Six Chuter International LLC

SERVICE LETTER

Thursday, July 26, 2018 SL- 2018-01

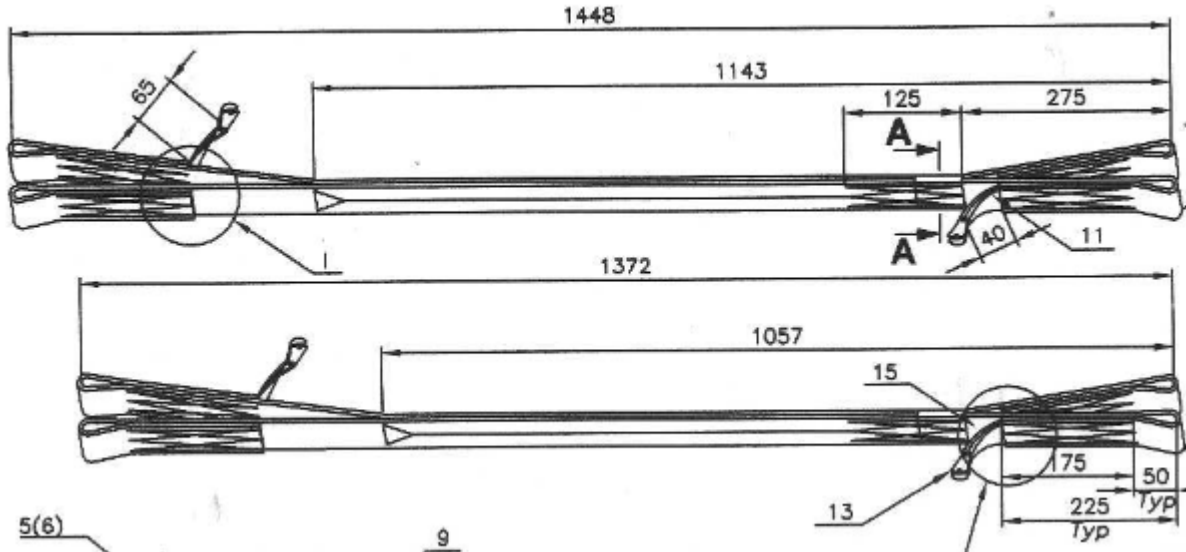
2.3 Material required per Aircraft These risers connect to the c.g. adjuster bracket using #6 oval or 9/32nd Delta Rapid Links
